**LAKE PONTCHARTRAIN, LA.
AND VICINITY
LAKE PONTCHARTRAIN
HIGH LEVEL PLAN**

**DESIGN MEMORANDUM NO. 19
GENERAL DESIGN**

**ORLEANS AVENUE
OUTFALL CANAL**

ENGINEERING CORRESPONDENCE LOG

**FIGURE 20**

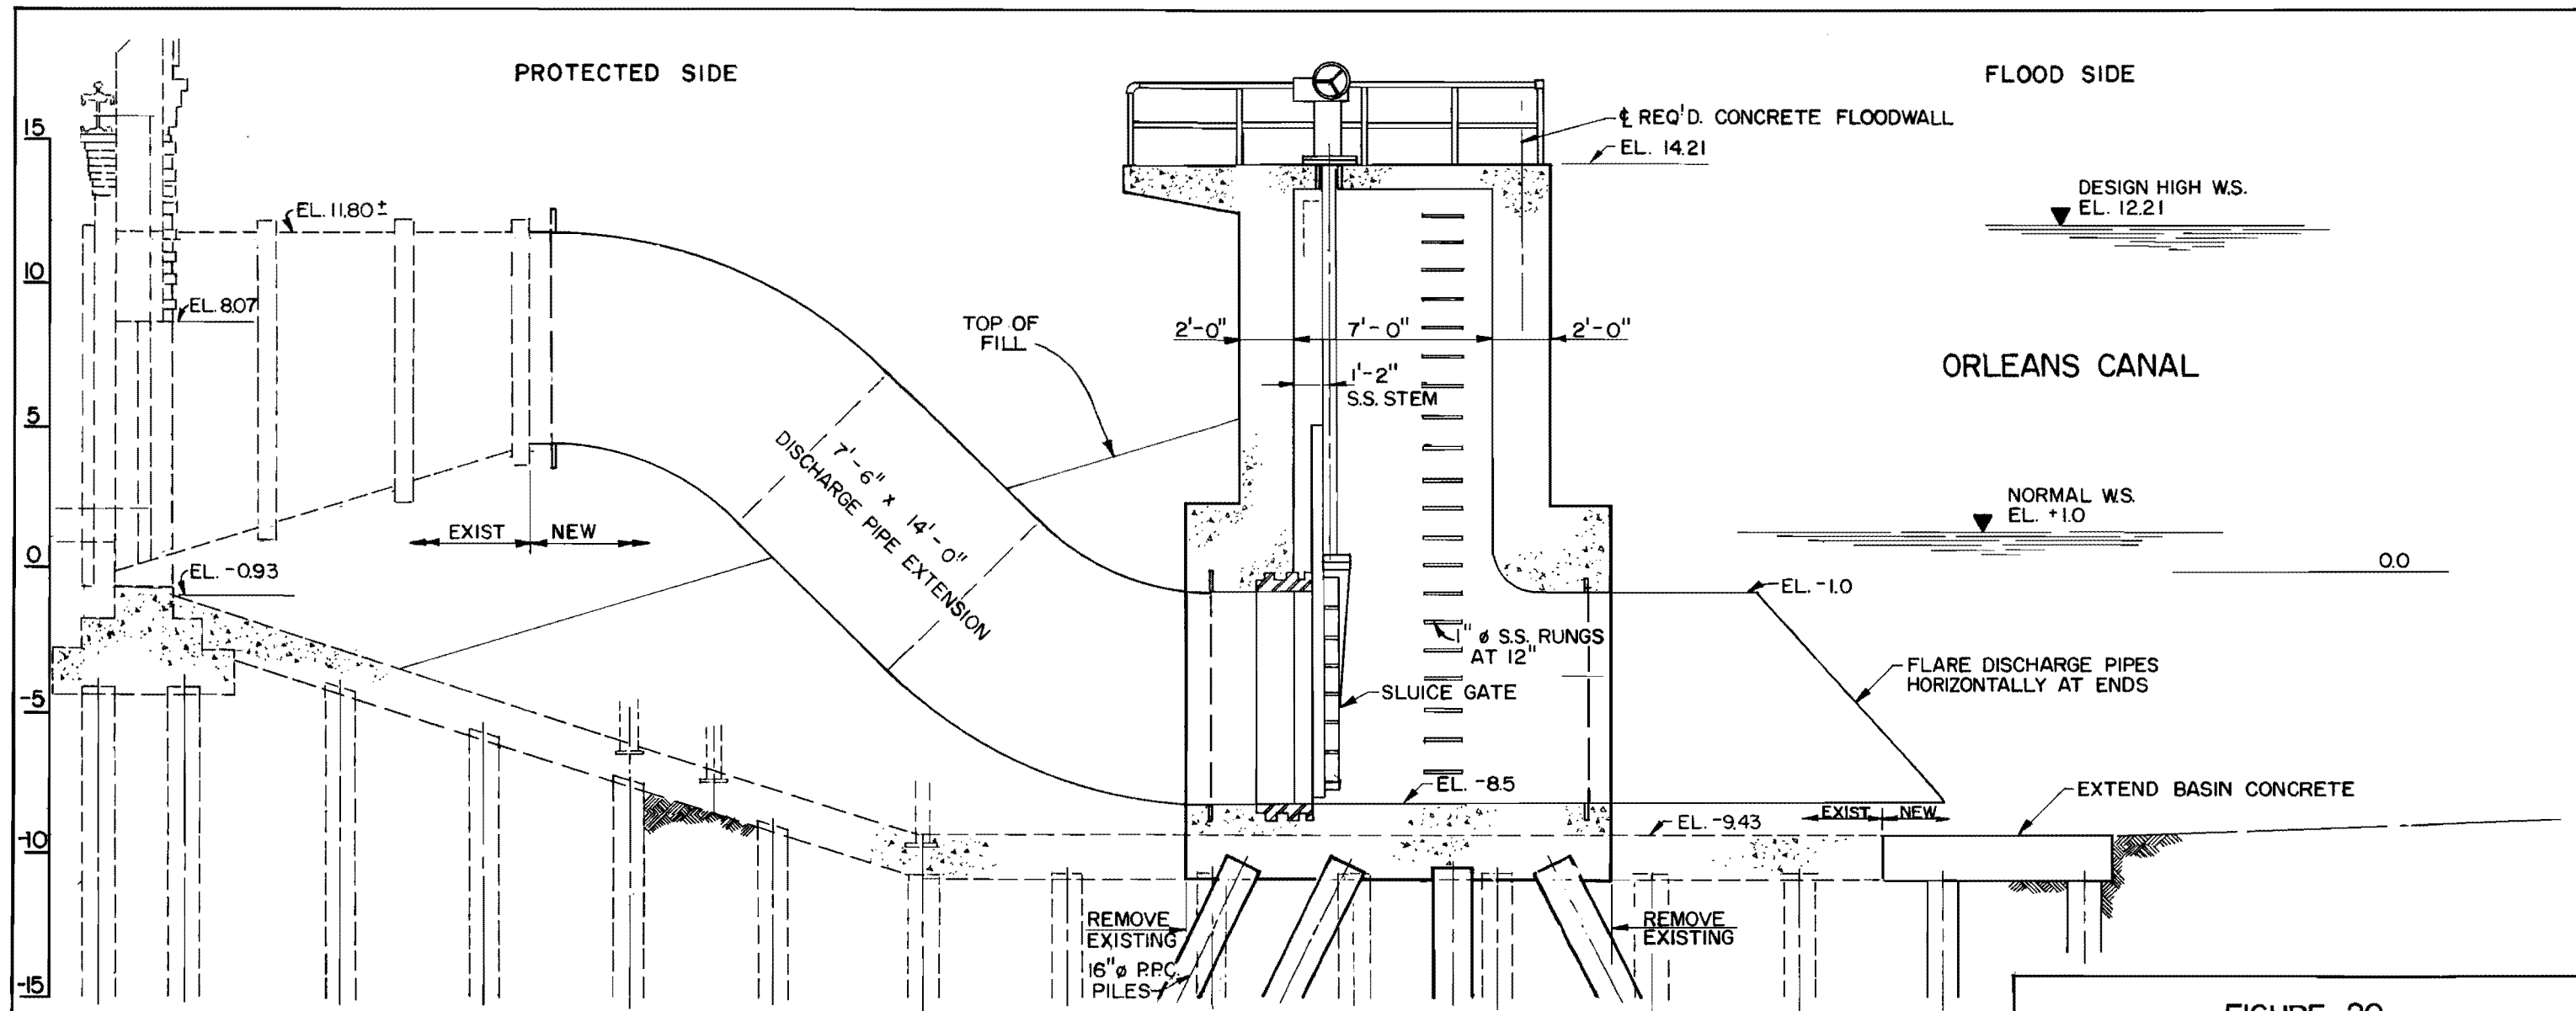
36. Reference figure 20 - Utilizing the sluice gate/floodwall structure for supporting the discharge lines is unacceptable. Support structures and connection details, which will prevent the transfer of any loads to this control/floodwall structure, will be required.
